AGENDA MEMORANDUM

Drillen Subdivision (Final)

Request for a Waiver of the Wastewater Infrastructure Construction Requirement in Sections 8.1.4.C, 8.1.5, and 8.2.7.A of the Unified Development Code (UDC) and exemption from lot/acreage fees

Exhibit E

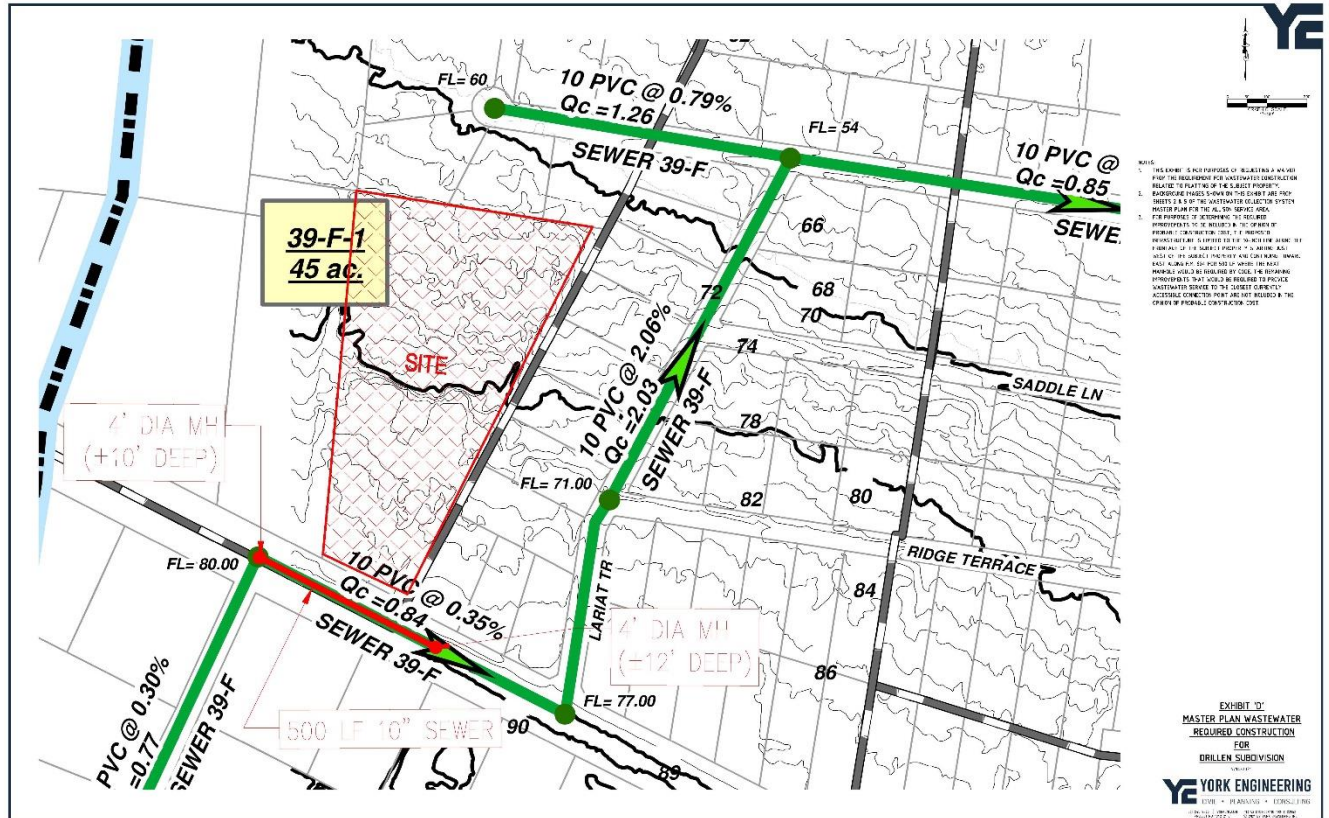
The route to this Lift Station is shown on Exhibit E. The Riverview Lift Station has a 10” PVC force main that connects to an existing Lift Station (Woodriver) approximately 8,211 linear feet away. This lift station is part of a system that eventually connects to the Allison Wastewater Treatment Plant on Leopard Street.
